Meeting Summary

On Friday, September 27, the City of Sacramento held the second stakeholder focus group meeting for the Sacramento Valley Station Master Plan. The meeting took place from 1:30 – 3:30 p.m. at Sacramento City Hall in Room #1119, located at 915 I Street in Downtown Sacramento.

SACRAMENTO VALLEY STATION MASTER PLAN

FRAMEWORK - TRANSIT ACCESS

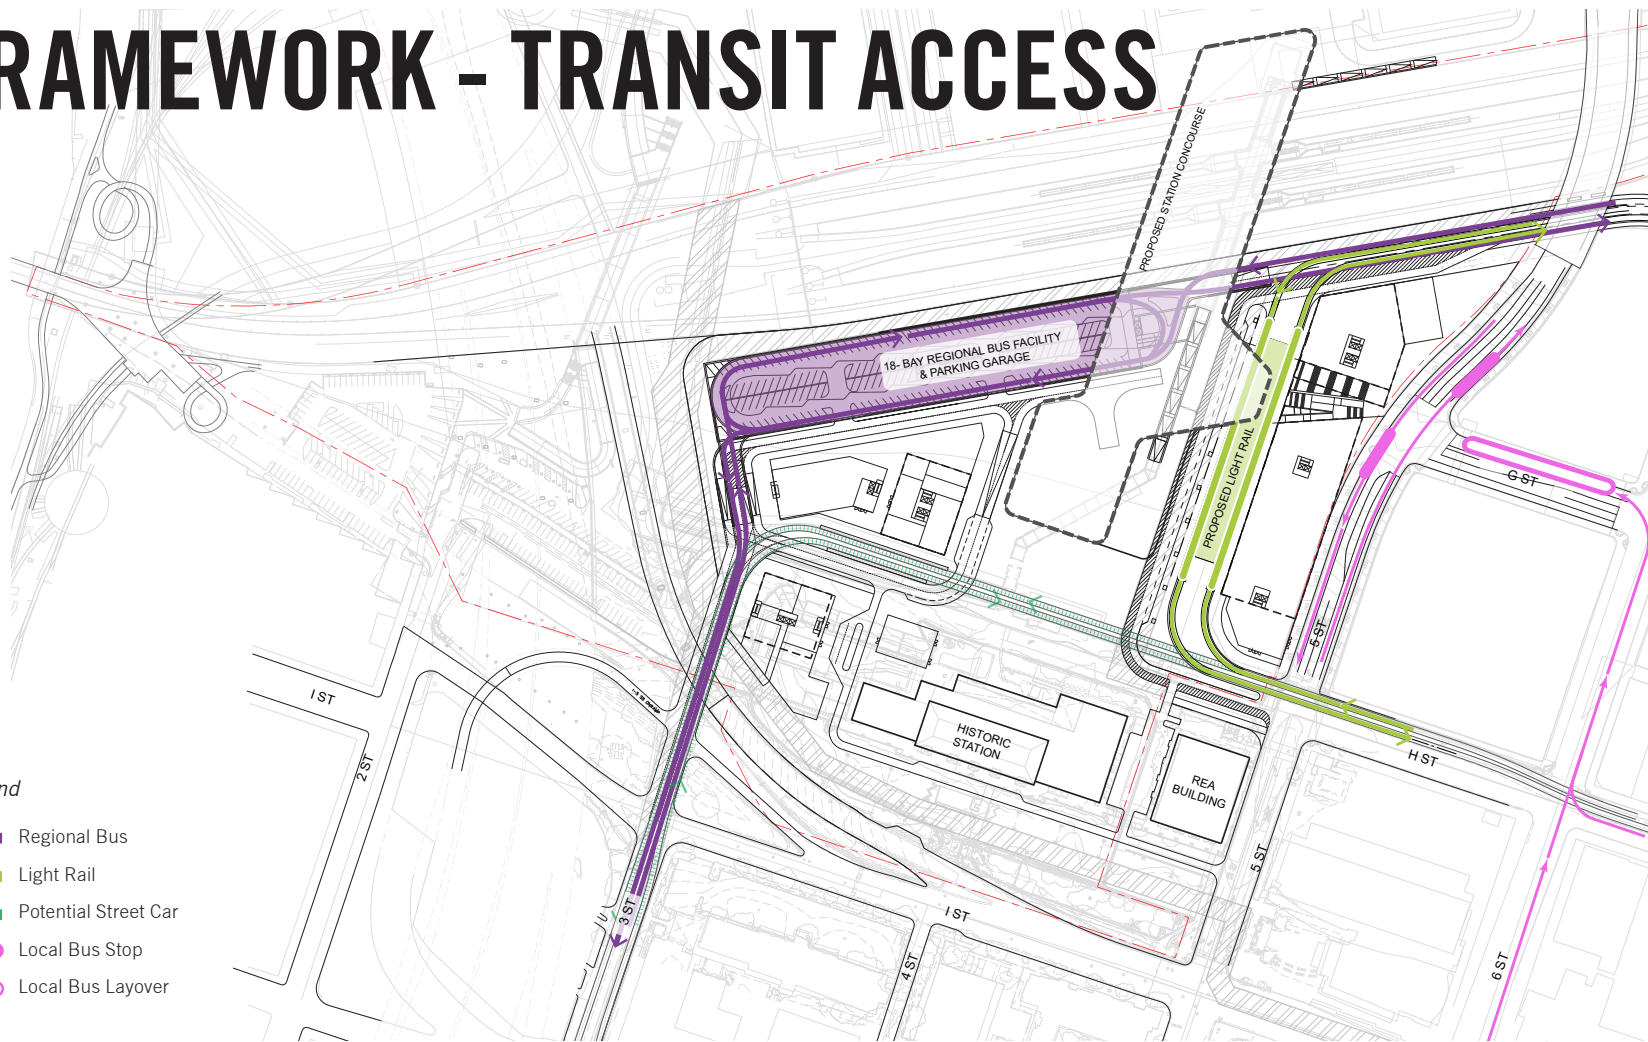
- Sacramento Regional Transit is okay with the southbound local bus stop at 5th and G Street being located within the intersection.
- Is there a possibility for buses to stop and layover on the south side of G Street in the eastbound direction? Based on the position of the street network, there does not seem to be a direct way to get the #38 and #62 bus to the westbound terminal on L Street and exit via J Street.
- It would be ideal for Sacramento Regional Transit to have as many buses as possible from the south and east to terminate on eastbound G Street. Currently, the westbound stop on G street accommodates the #51 bus. Without stops on eastbound G Street, it is not considered an operational stop. It wouldn't work for the #30 and #38 bus.

- What is the interaction between buses and bike lanes at this location?
 - Yes. The concepts of operations for each bus transit should be examined so that we don't have transit flow issues.

- None.
2. What and how many bicycle facilities should be provided in the station area?
 - Always slightly more than the market demand needs. G Street could use some access points to intercept bikes/scooters but also e-lockers.

FRAMEWORK - BIKE NETWORK

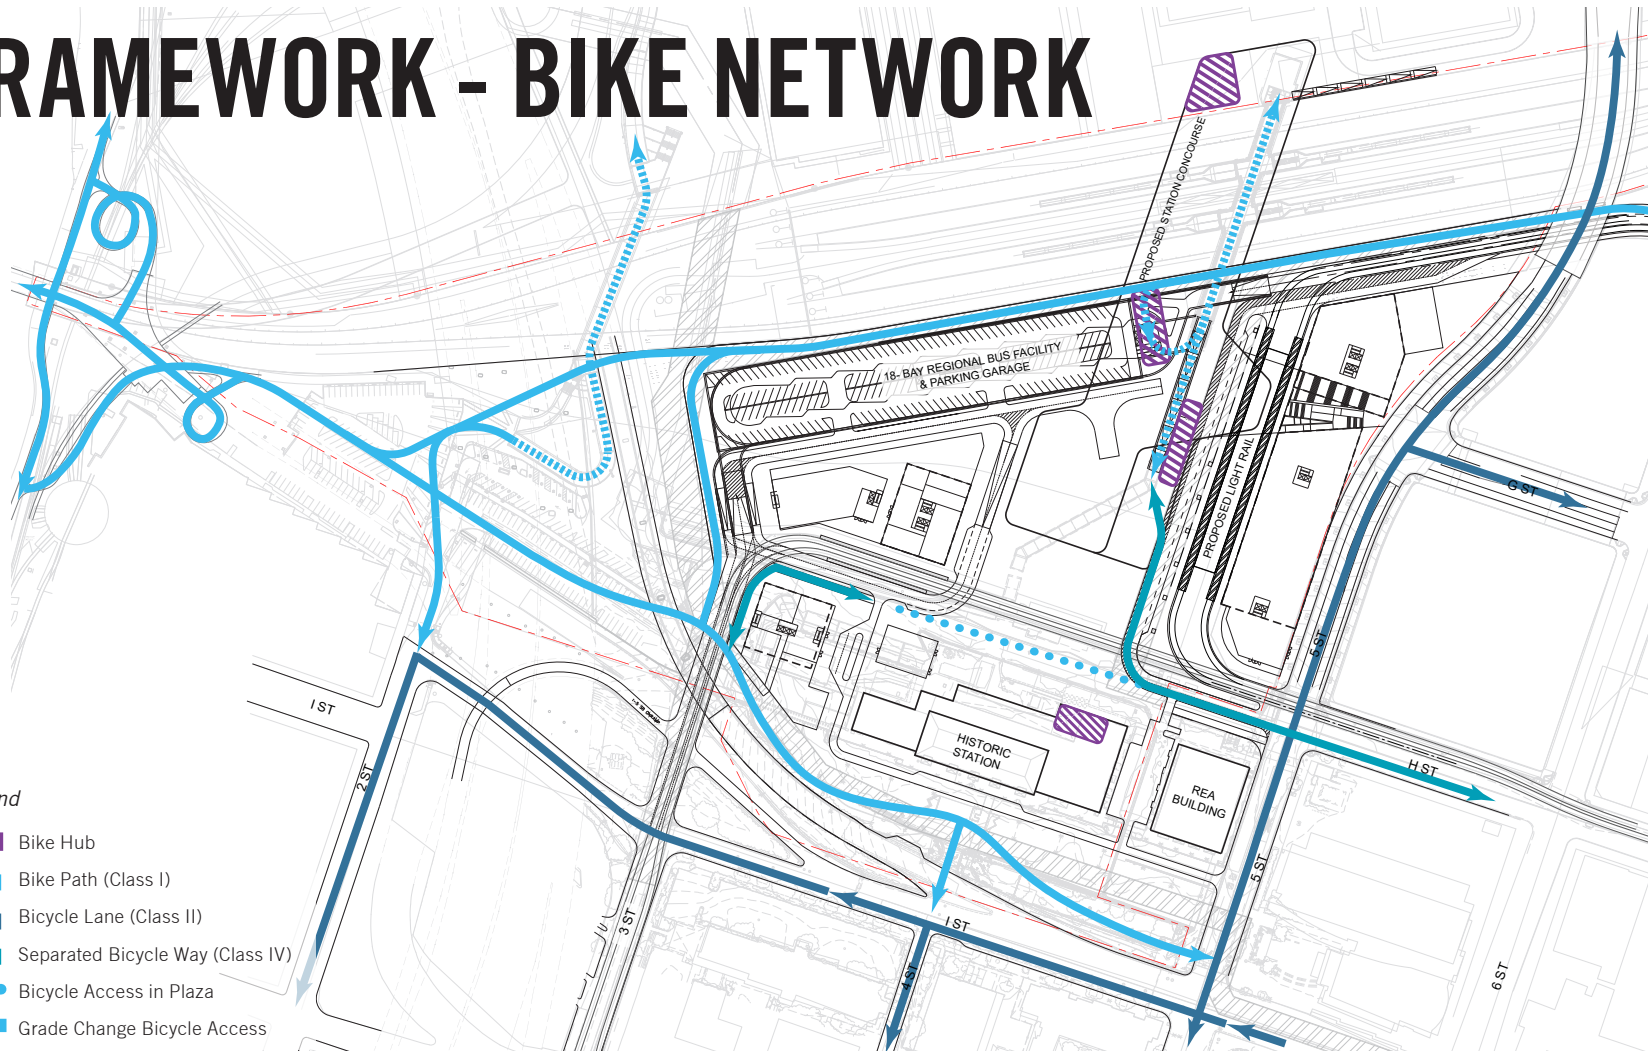
- Include electrical service at some of the racks for charging e-bicycles.
3. Which of the desired amenities should be included within the proposed bike facility at the tunnel level (-15'-0)?

- The lockers should be e-lockers.

- Yes, but intercept points are missing in some places like G Street Would like to also see the intercept from the Railyards side -- for context.
- More or less. Near all entrances.

PHASE 01 - PARKING LEVEL PLAN PROGRAMMING

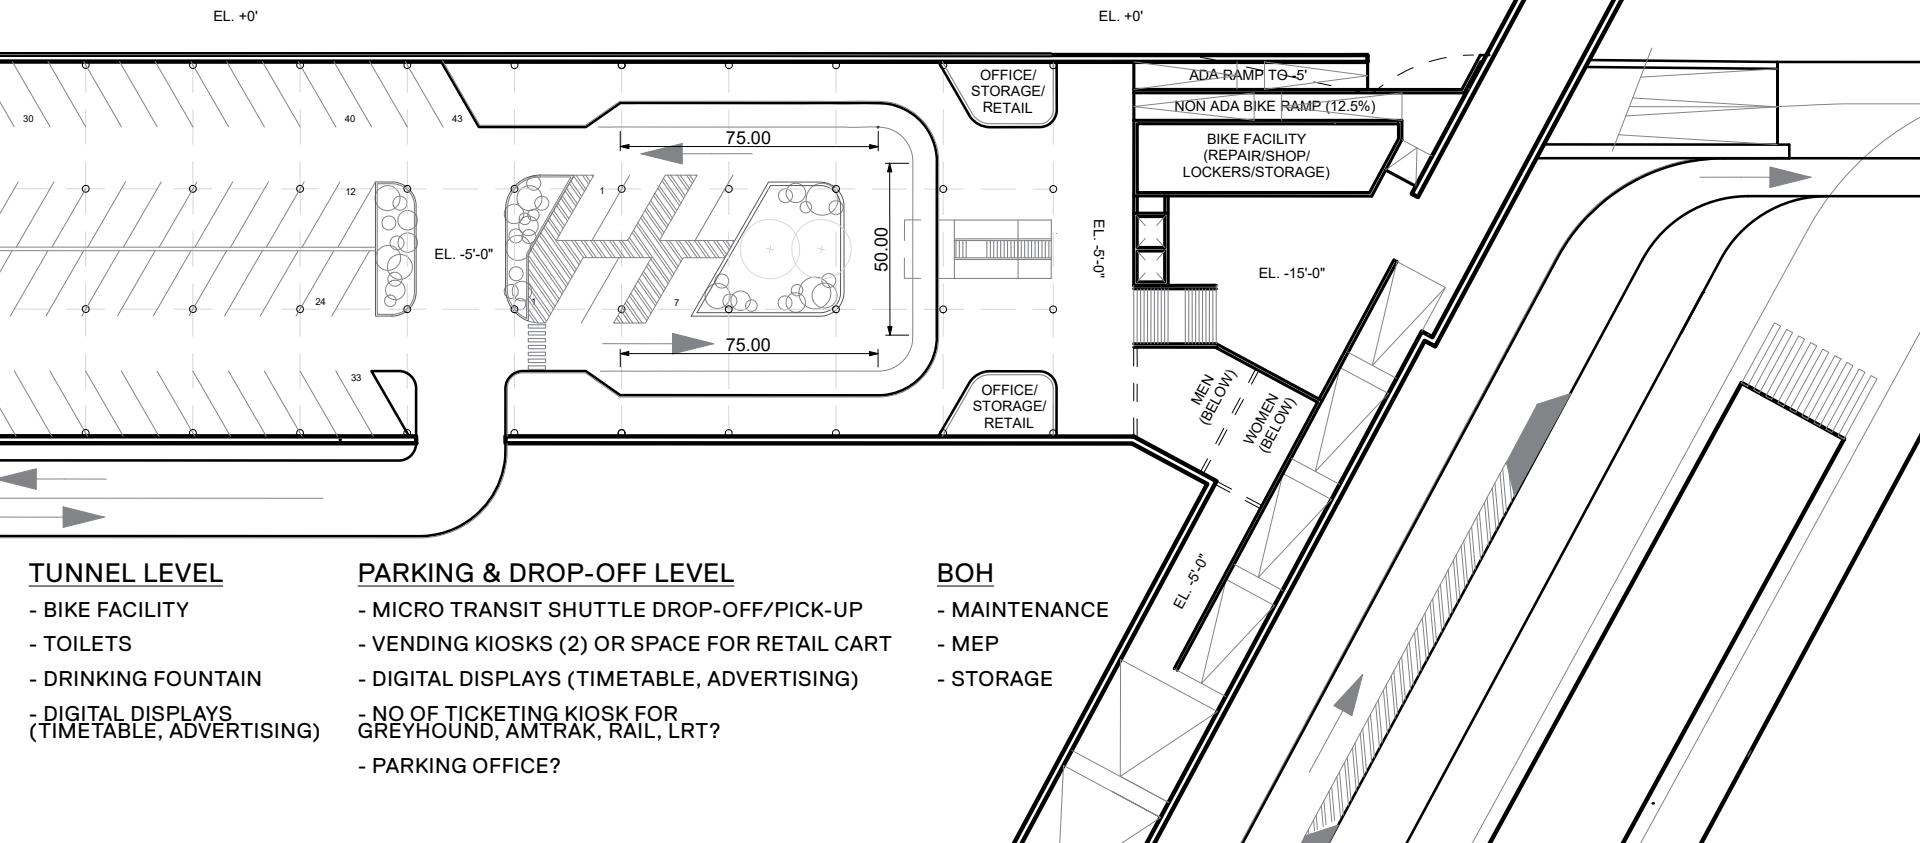
- The use of ticketing machines is going away. If there must be machines, they should be ready to be phased out.
- We do not use ticket kiosks.
- In addition to ticket machines, there should be a ticketing counter where people can have any questions answered or an alternative when machines are out of service.

- Toilets, and day-use lockers (i.e. Amazon lockers) to facilitate multiple uses and attract diverse riders as well as real time information signs.
- Passenger information display signs and conduit going to the right intercept points. Trash cans are needed near elevators near transfer platforms.
- None.
- I would like to see phone charging stations / outlets, workspaces / outlets for laptops, postal services with mail drop-off, and space for City of Sacramento information and brochures to promote the City.
- Nothing that makes the walls longer. Café and bar, coffee shop, etc.

PHASE 01 - BUS CONCURSE LEVEL PROGRAMMING

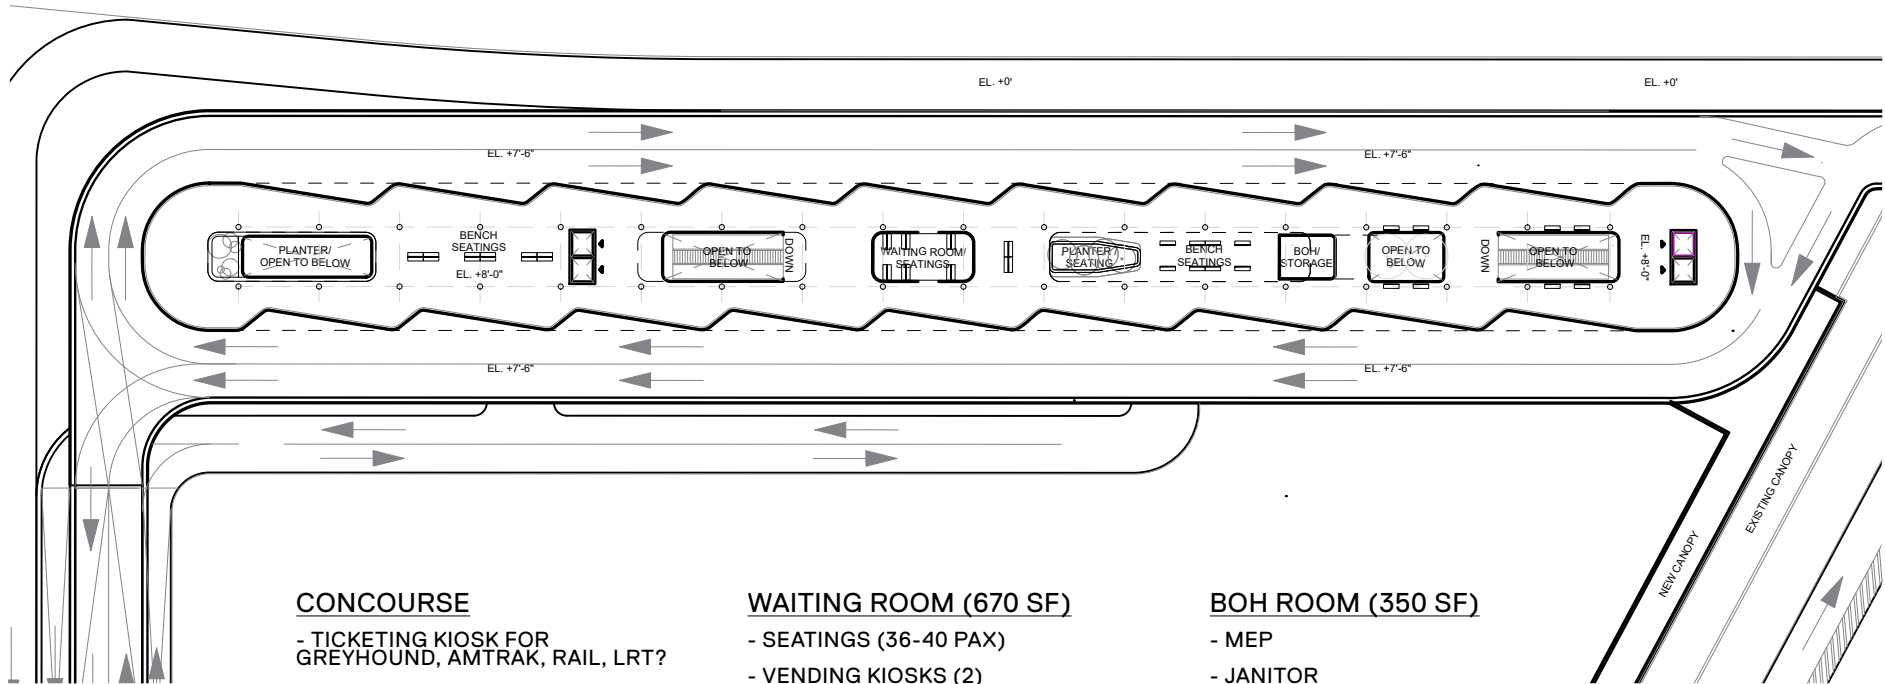
- Toilets should be available at the waiting room.
- Toilets should also be on the parking level below.
- Ticket machines or kiosks should only be included as needed in the short term – moving away from this with Cal-ITP project.
- Wouldn't vending machines conflict with restaurants at the station?
- Storage of what?
